Addendum 3 for RFB927940-04

Project Name: WRC Decentralization Phase 4 & Fire Alarm Phase 3 (9279.40 & 9279.41) Bid Issuance #4
DAS RFB #: 927940-04
DAS Project #: 9279.40 & 9279.41
Date: 6/2/2026

13-AD00

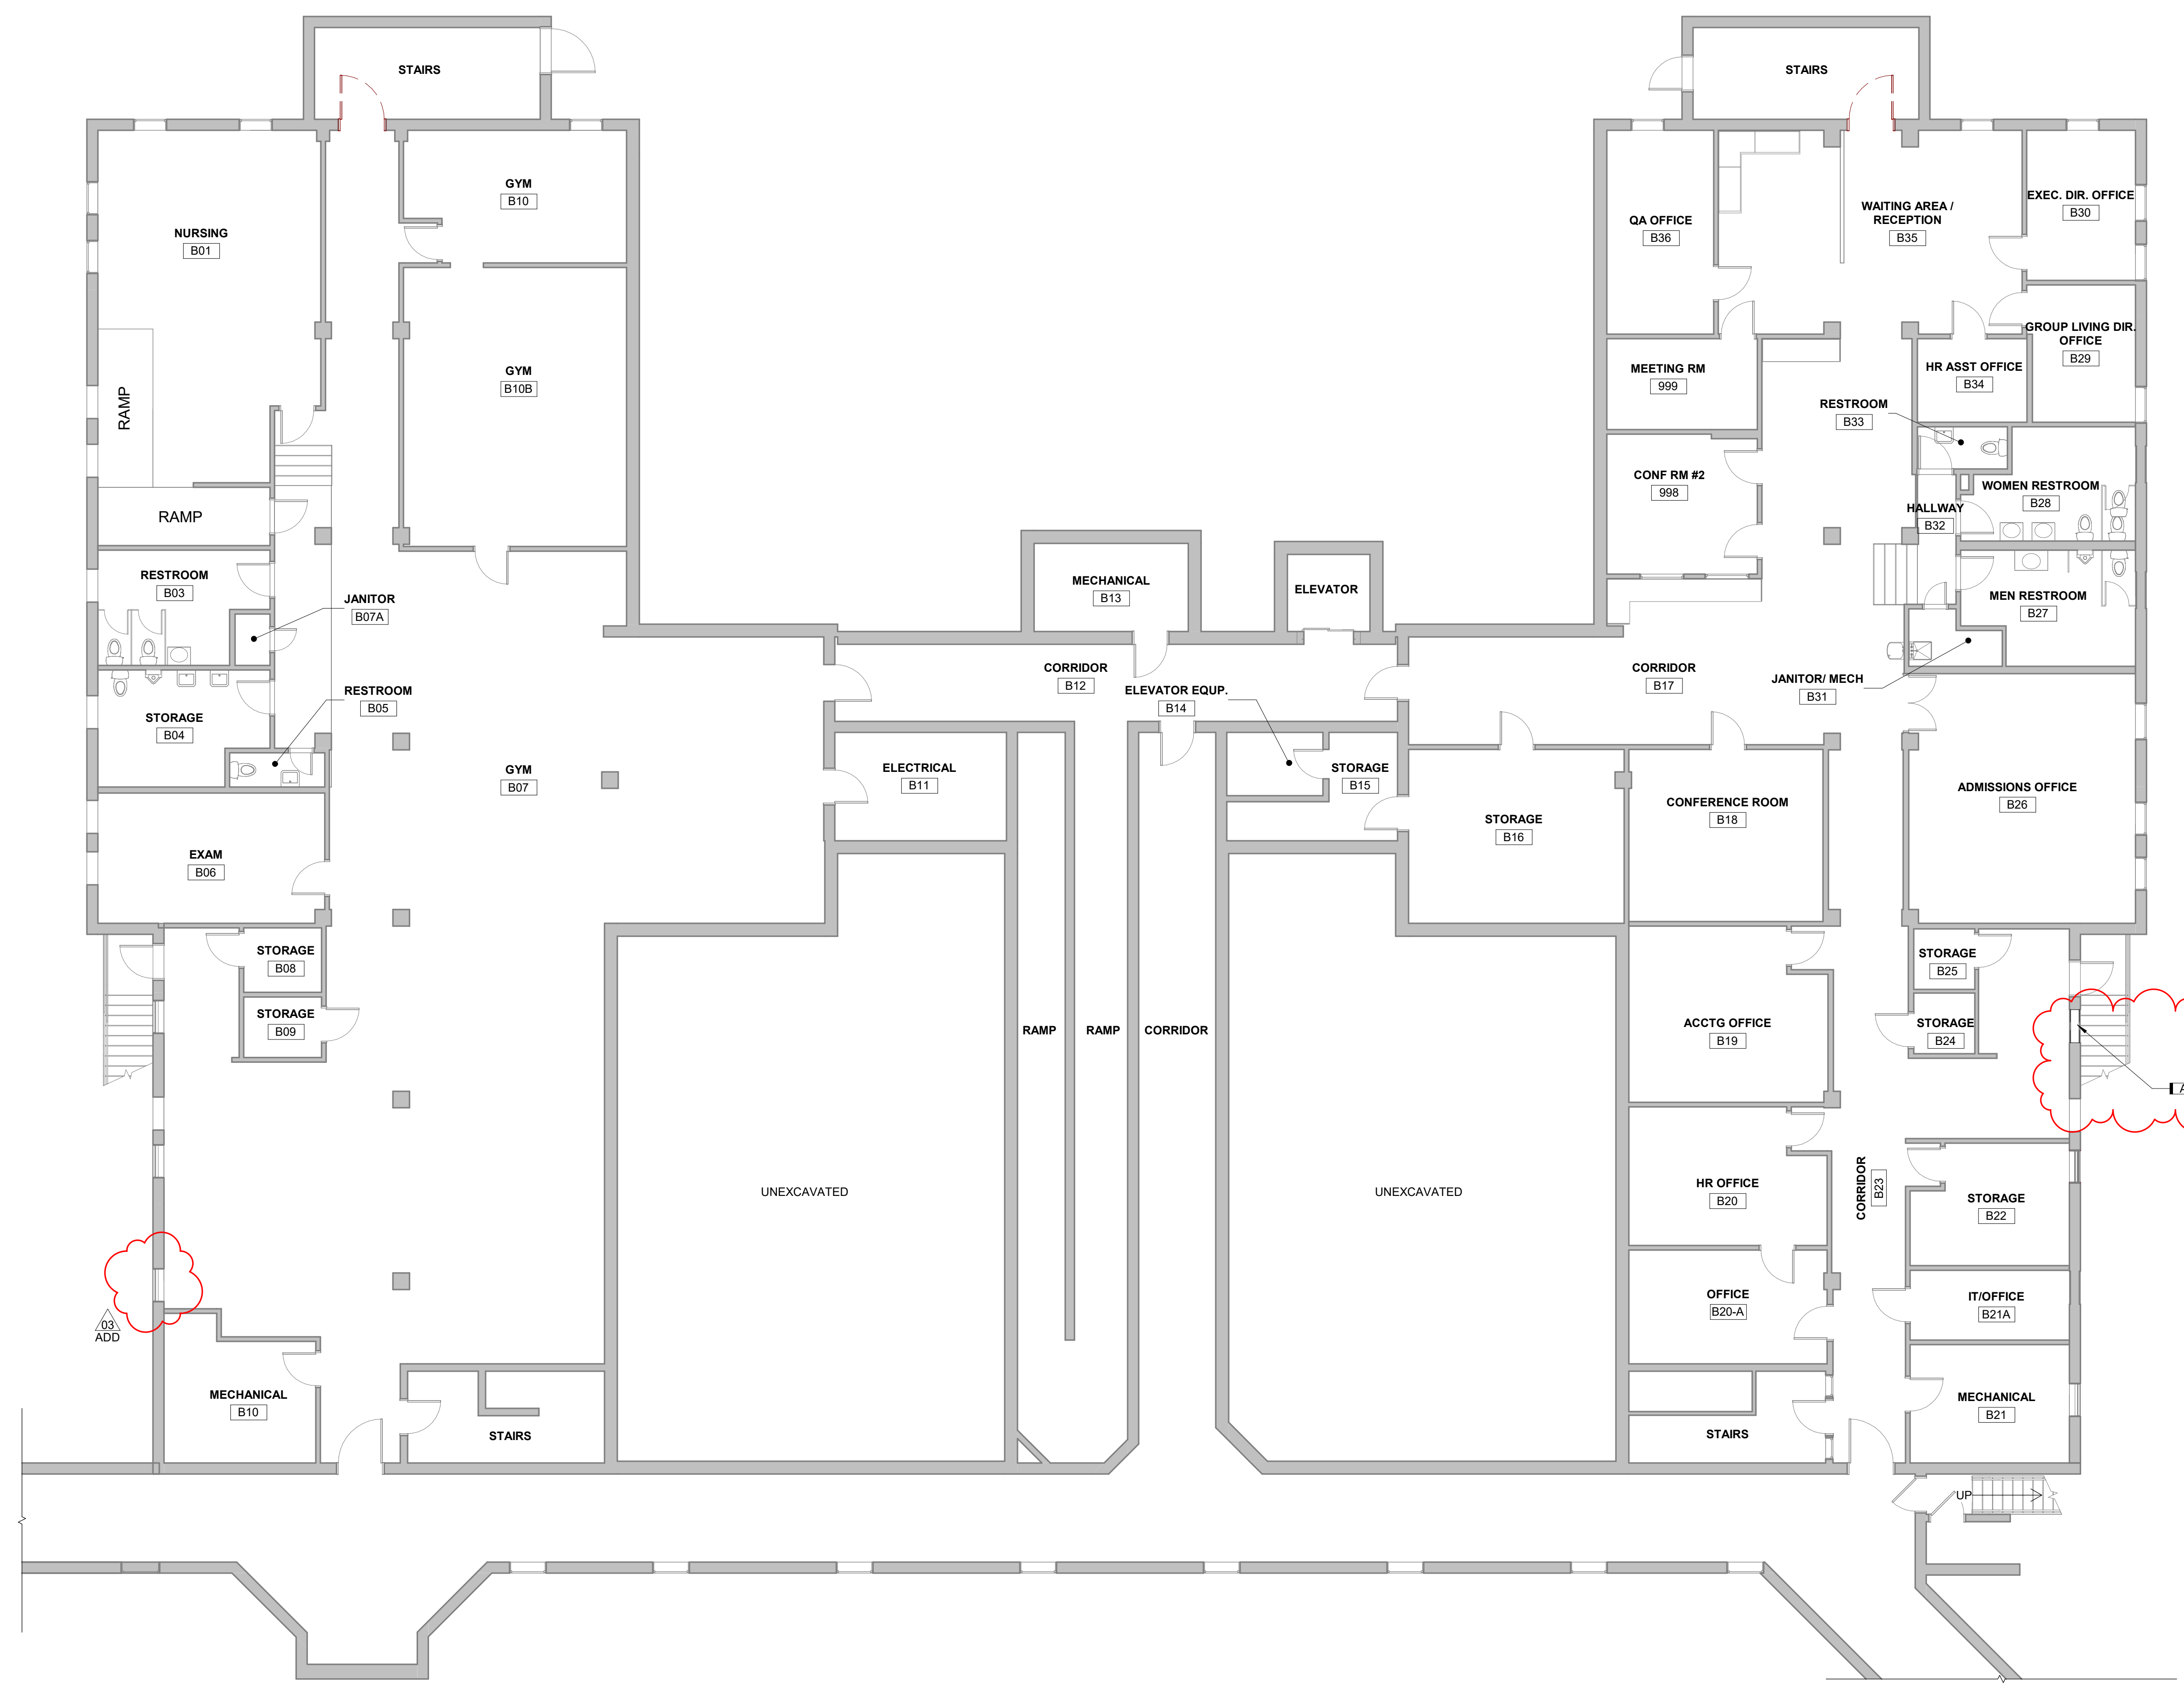
- **REVISE** Keynote pointing to heating coil I mechanical room to 13-MD2.
- **13-AD00 – BASEMENT DEMOLITION PLAN – BUILDING C & D**
 - **DELETE** window demolition shown on west side of Building C

- **ADD** demolition and keynote of plywood window infill on east side of Building D
- **13-A100 – BASEMENT FLOOR PLAN – BUILDING C & D**
 - **ADD** keynote A24 on west side of Building C

KEYNOTES	
KEY	NOTE
AD11	REMOVE EXISTING FLYWOOD WINDOW INFILL AND PREP OPENING FOR INSTALLATION OF NEW LOUVER - SEE MECHANICAL DRAWINGS

B6 BASEMENT FLOOR PLAN - BUILDING C & D
1/8" = 1'-0" 0 12"

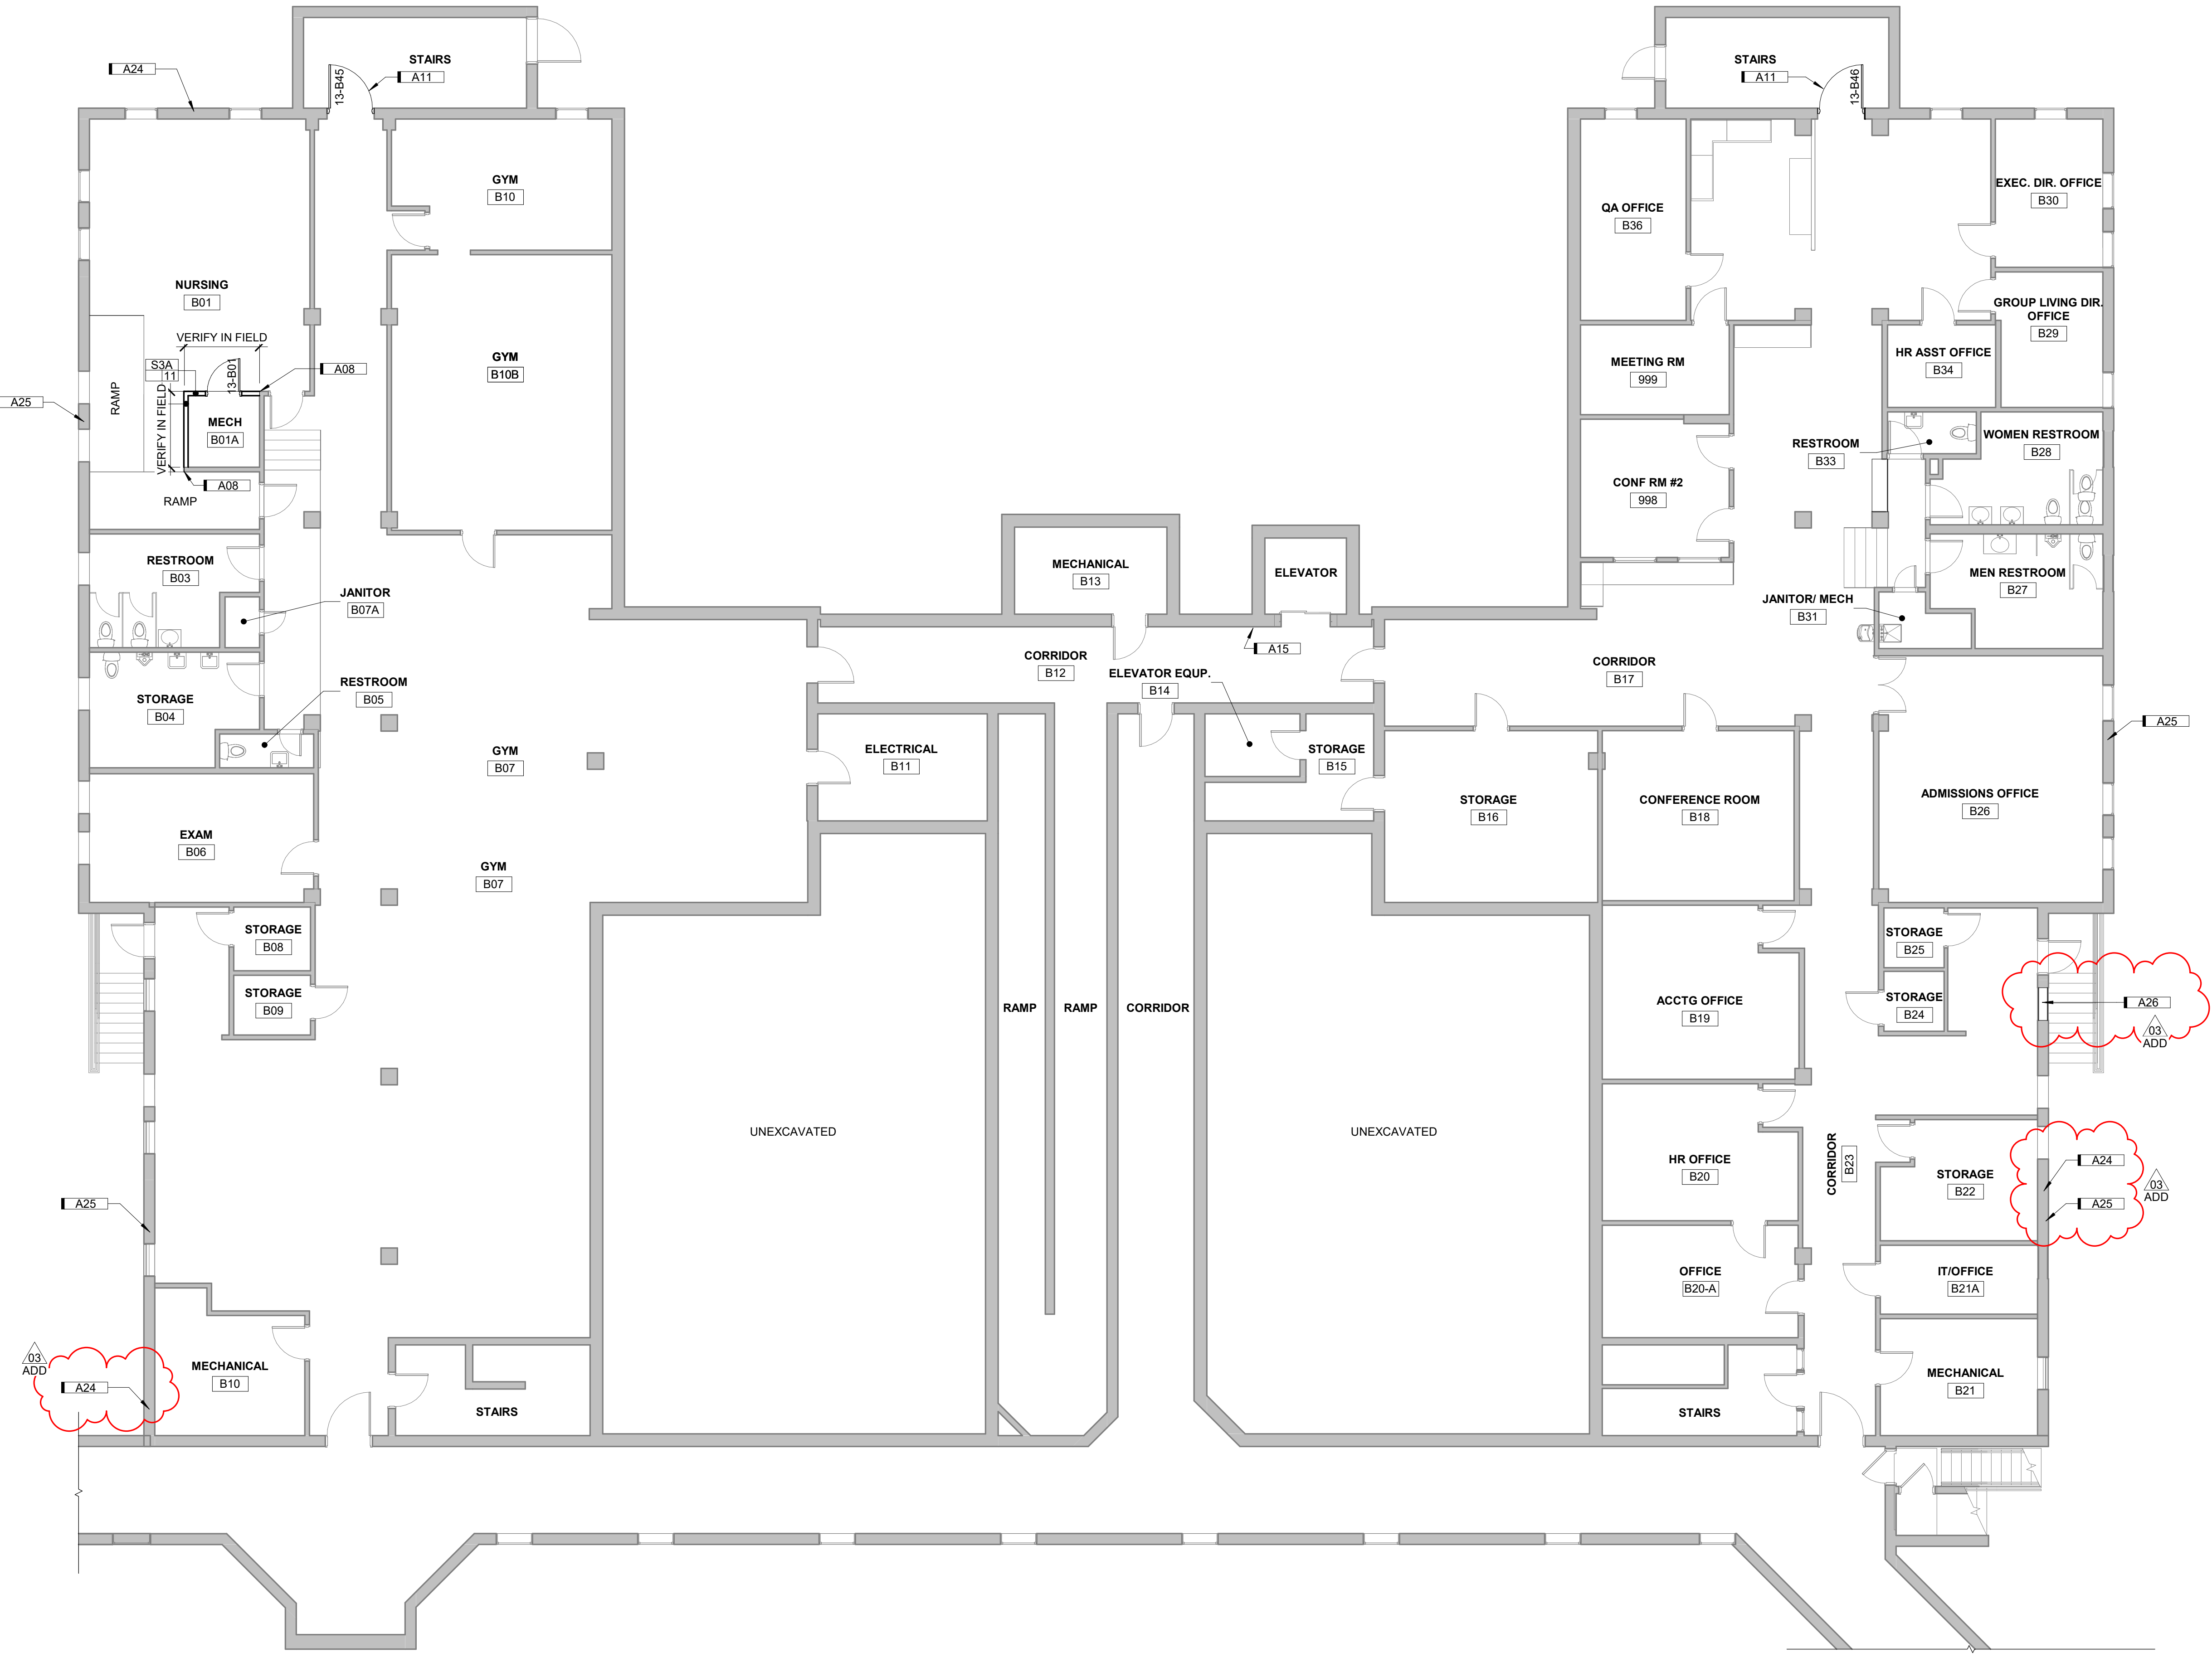
- **ADD** keynote A26 and keynote A25 on east side of Building D

13-FP100

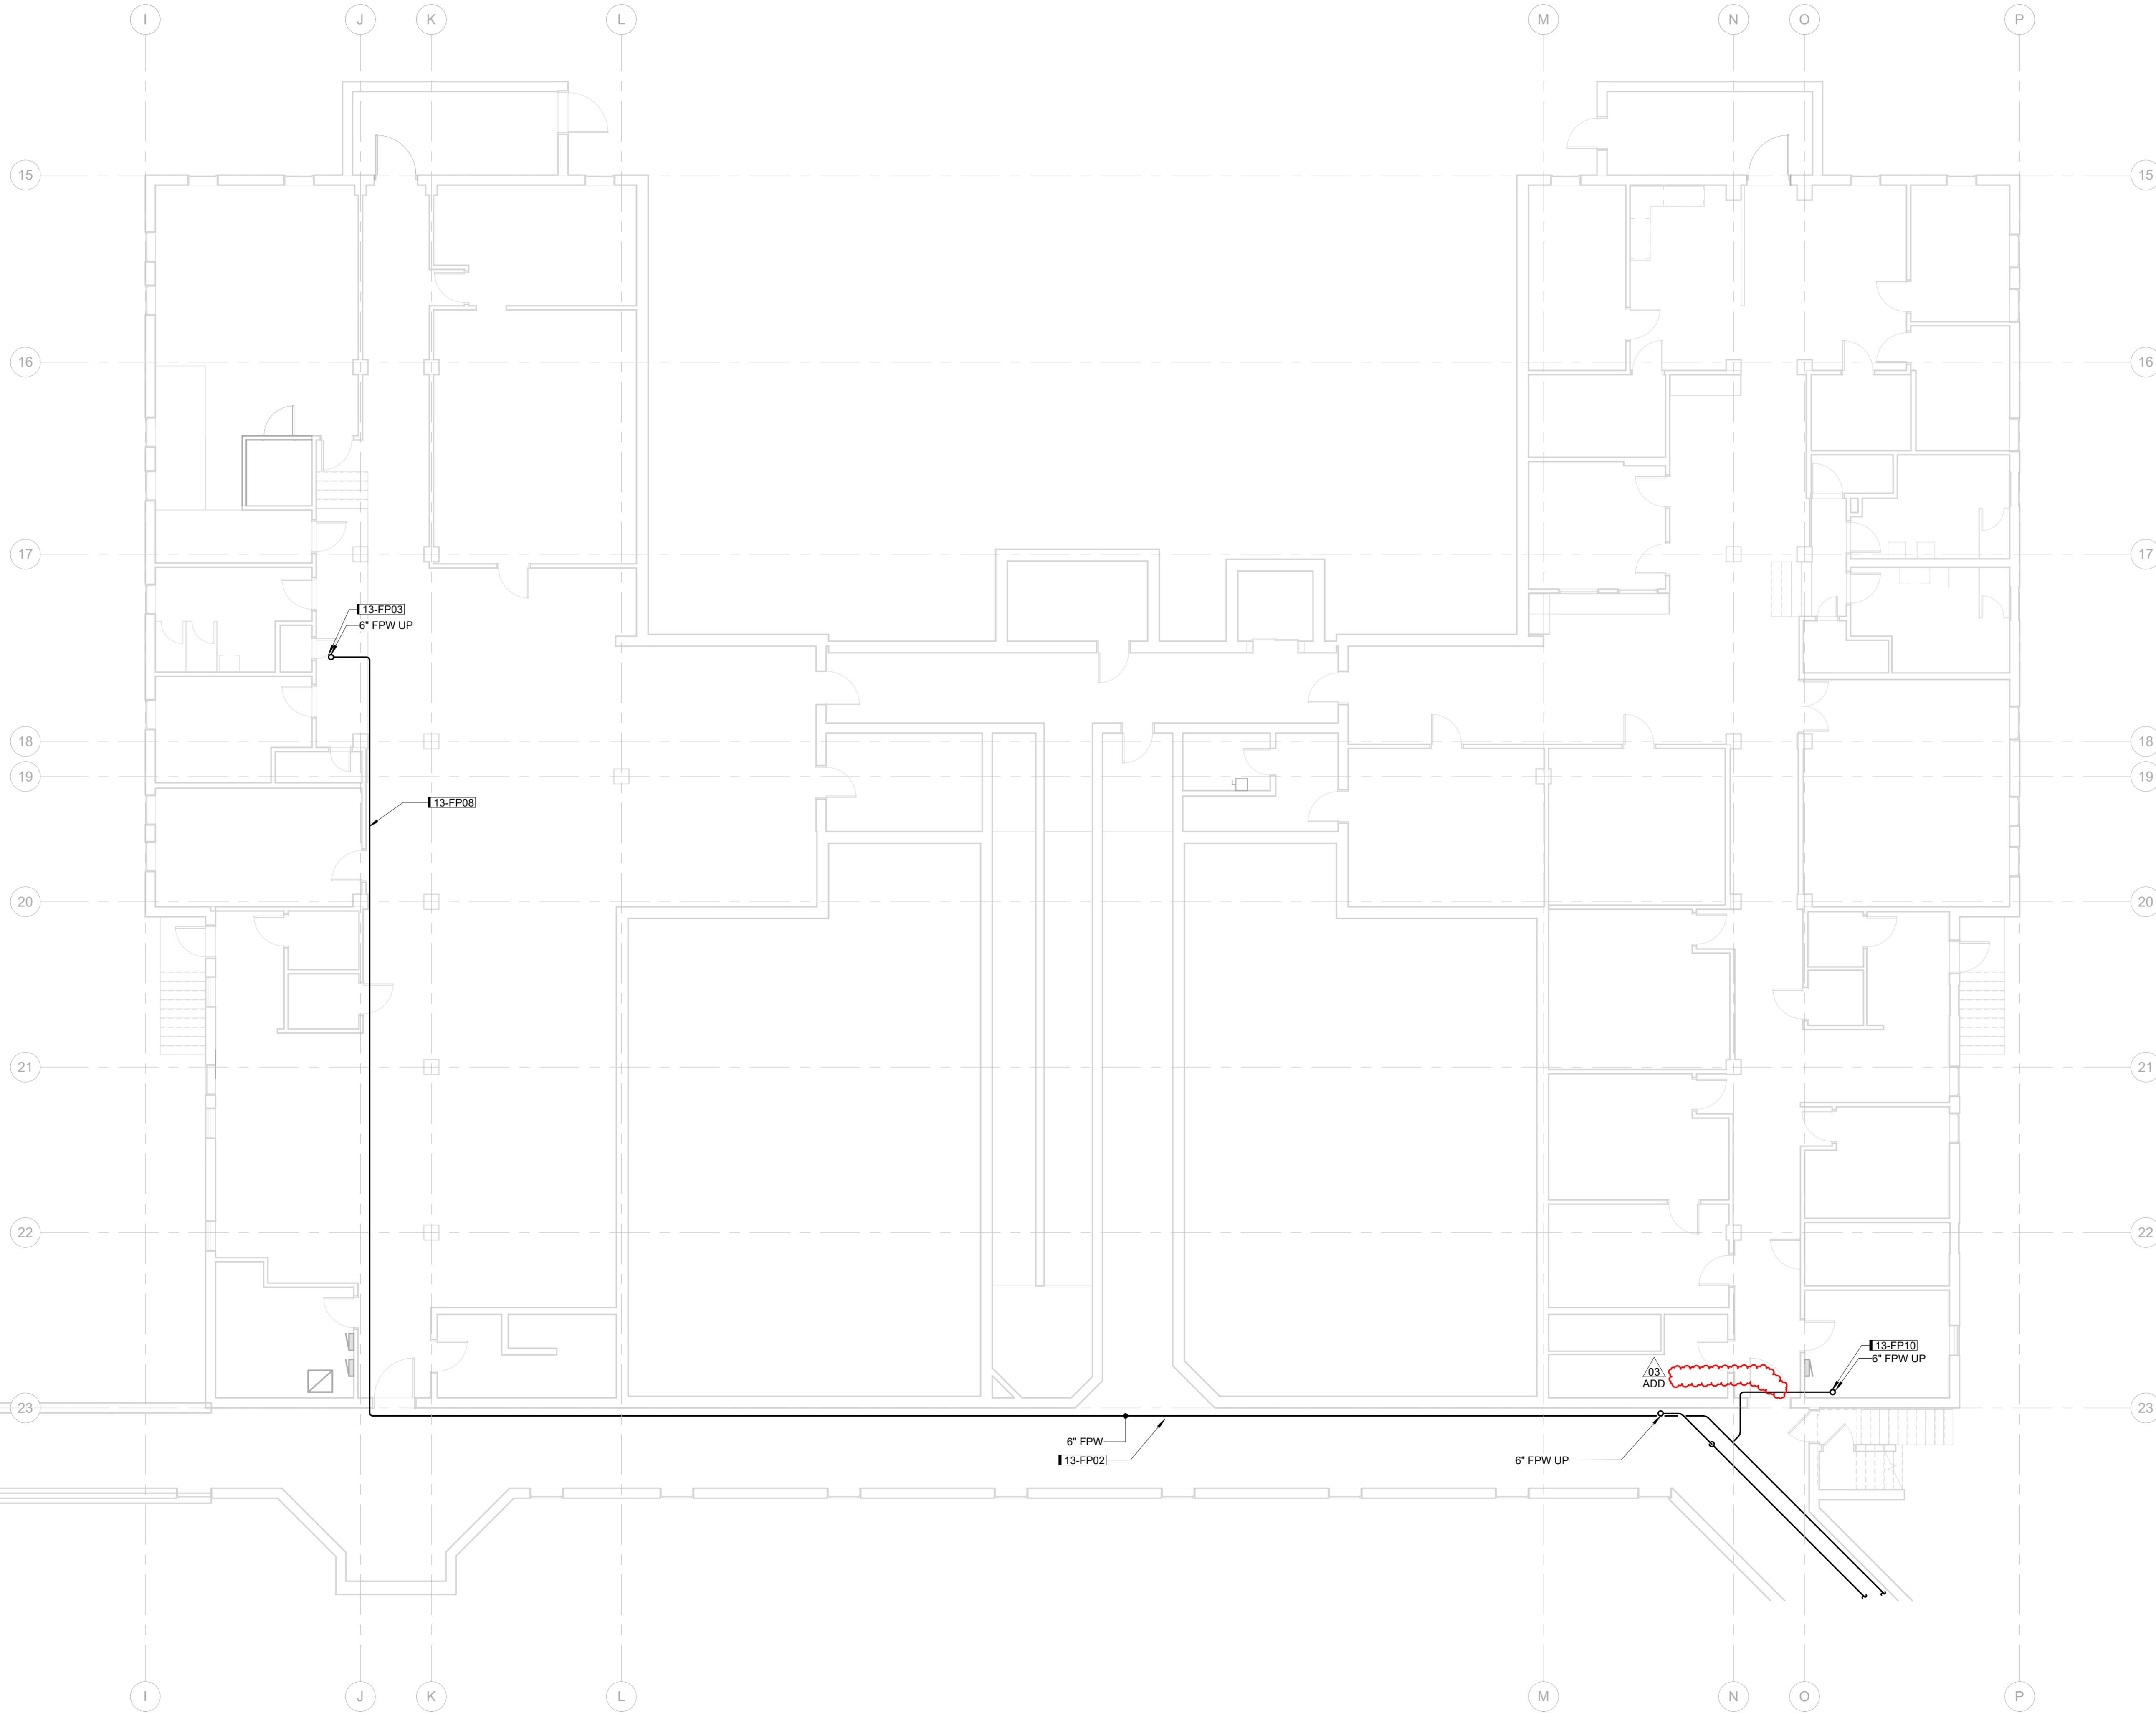
- **13-E202 – SECOND FLOOR C&D – POWER PLAN:**
 - **REMOVE** Keynote 09-E033 from keynote key.
- **13-FP100 – BASEMENT FIRE PROTECTION PLAN:**
 - **REMOVE** Keynote 13-FP08 from piping inside Building D basement.
